PATTERSON LAKE ADDITION

Re: S/D 95-12 - PATTERSON LAKE ADDITION (Final Plat)

Re: S/D 95-12 PATTERSON LAKE ADDITION (Final Plat)

CASE NUMBER: S/D 95-12 PATTERSON LAKE ADDITION

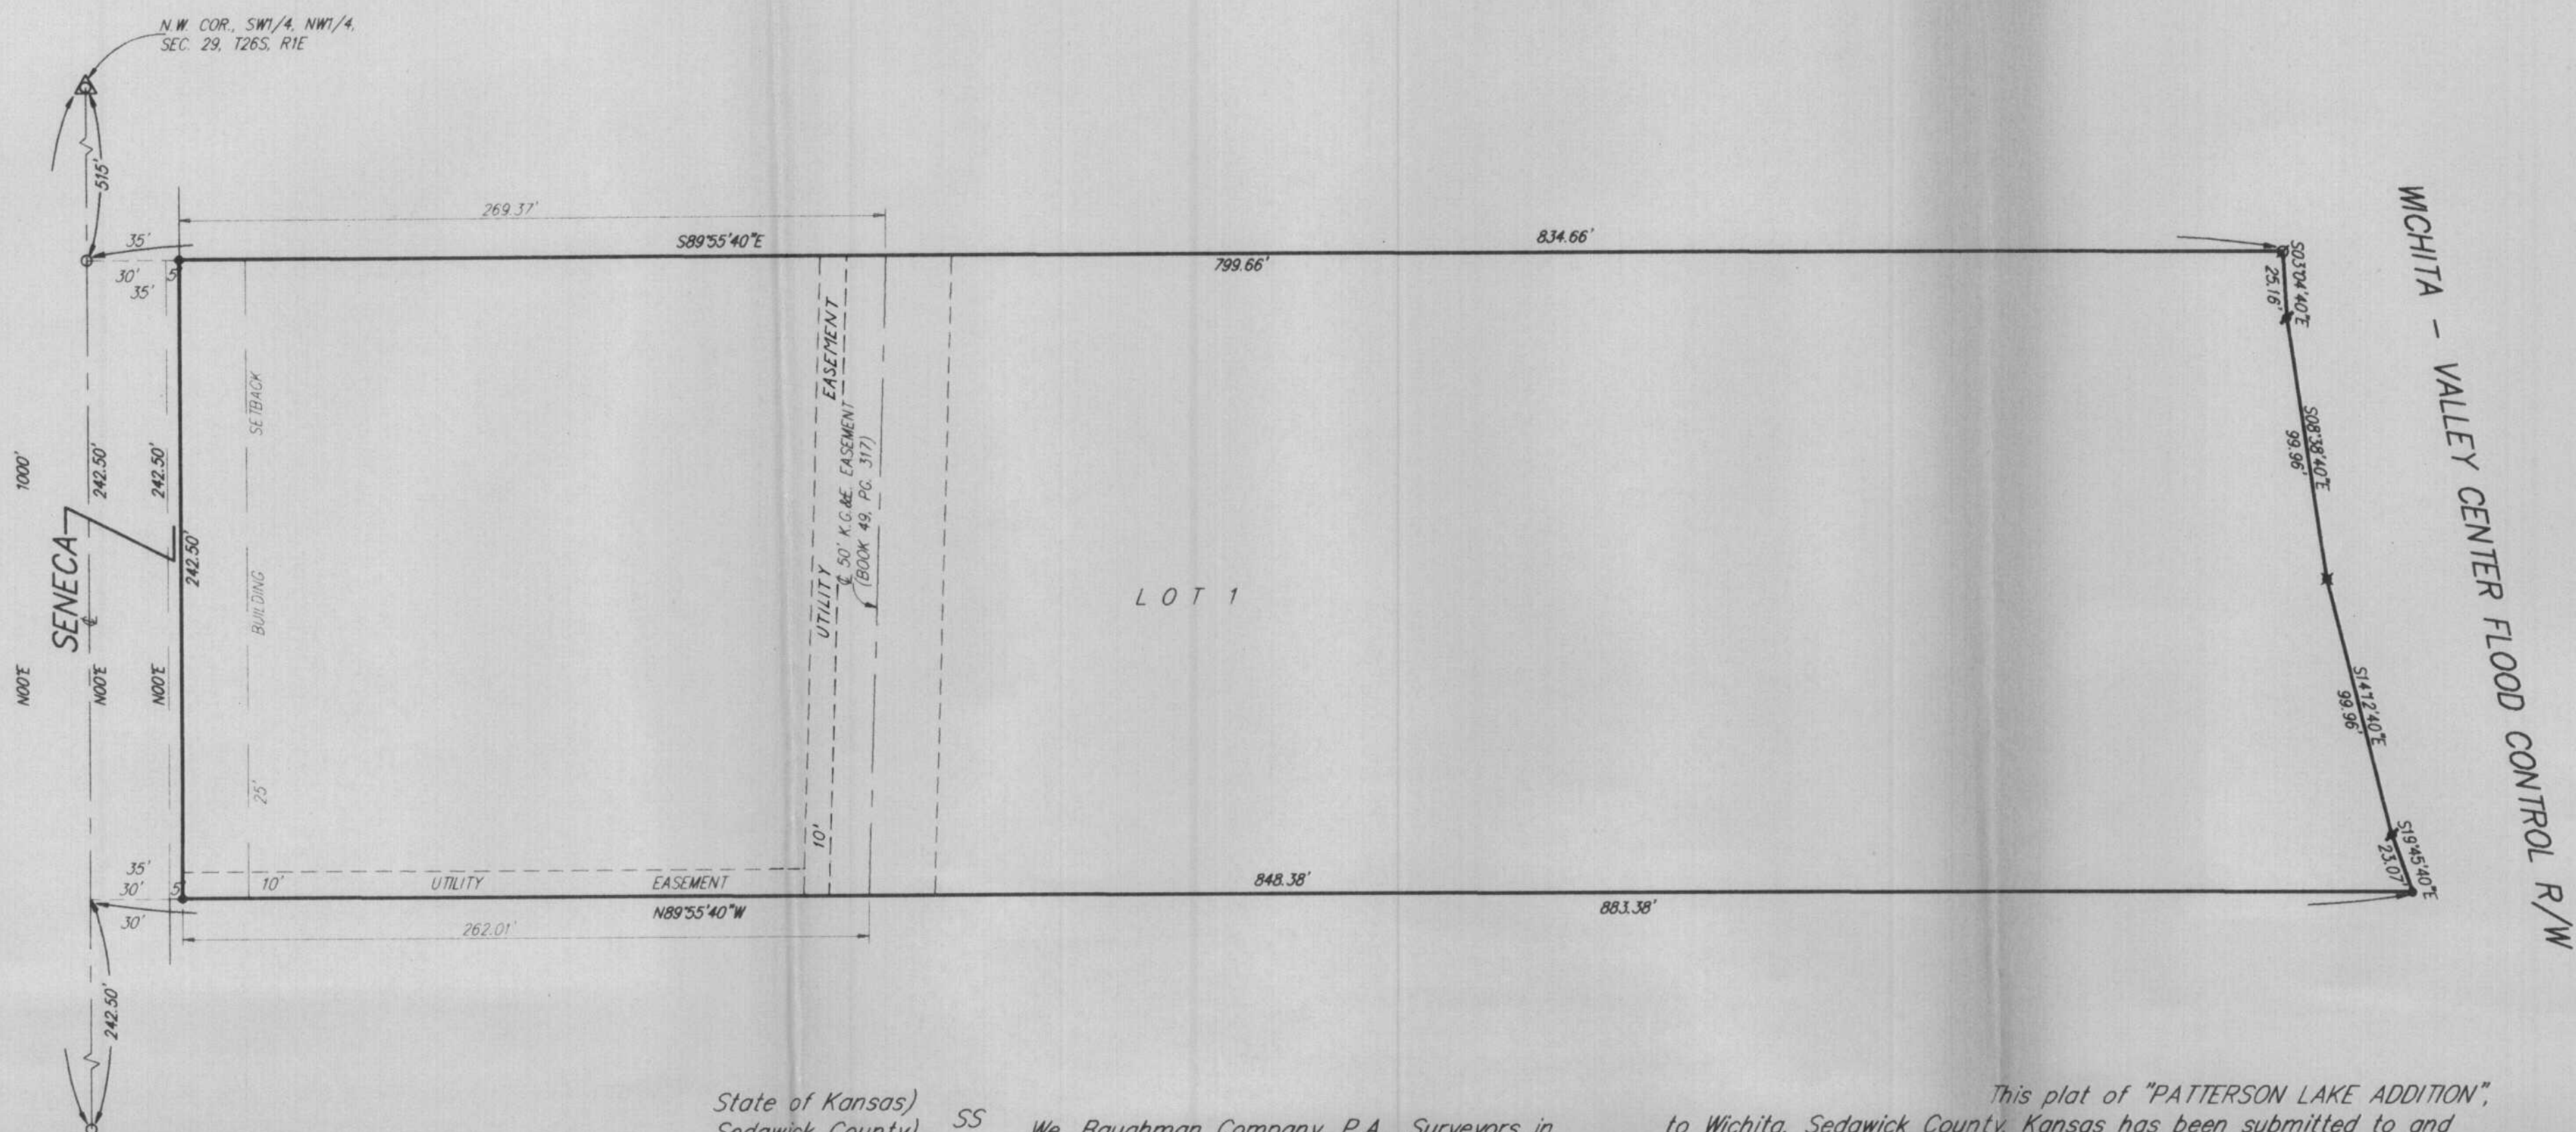
- ~~D.~~ As noted by Engineering minimum building pad elevations shall be established for this site. The final plat tracing shall provide proper documentation and related information (note in plat's text, benchmarks, City datum & MSL, etc.).

- ~~F.~~ Prior to this plat being released for recording, the shed indicated within the 25-foot setback shall be removed. A letter shall be submitted to Planning indicating removal of the shed. The applicant is also advised that the indicated carport at this site could be in violation of the required sideyard setback. If the carport and existing garage remain detached from any

future residence, a three (3) foot sideyard is typically required. If attached to a residence or if the garage were converted to a residence, a six (6) foot sideyard would be needed. Any such violation would require approval of a variance by the BZA.

OK slwamy
G. The final plat shall indicate the utility easements requested by Southwestern Bell which are indicated on the enclosed "marked" copy of the plat.

I. The applicant's engineer is advised that the Register of Deeds is requiring the name(s) of the notary public, who acknowledges the signatures on this plat, to be printed beneath the notary's signature.

- D. As noted by Engineering minimum building pad elevations shall be established for this site. The final plat tracing shall provide proper documentation and related information (note in plat's text, benchmarks, City datum & MSL, etc.).

- F. Prior to this plat being released for recording, the shed indicated within the 25-foot setback shall be removed. A letter shall be submitted to Planning indicating removal of the shed. The applicant is also advised that the indicated carport at this site could be in violation of the required sideyard setback. If the carport and existing garage remain detached from any future residence, a three (3) foot sideyard is typically required. If attached to a residence or if the garage were converted to a residence, a six (6) foot sideyard would be needed. Any such violation would require approval of a variance by the BZA.

- G. The final plat shall indicate the utility easements requested by Southwestern Bell which are indicated on the enclosed "marked" copy of the plat.
- H. The applicant shall install or guarantee the installation of all utilities and facilities which are applicable and described in Article 8 of the MAPC Subdivision Regulations. (Water service and fire hydrants required by Article 8 for fire protection shall be as per the direction and approval of the Chief of the Fire Department.)

MINIMUM BUILDING PAD ELEVATION FOR LOWEST OPENING TO STRUCTURES		
LOT	M.S.L.	CITY DATUM
1	1324.0	136.6
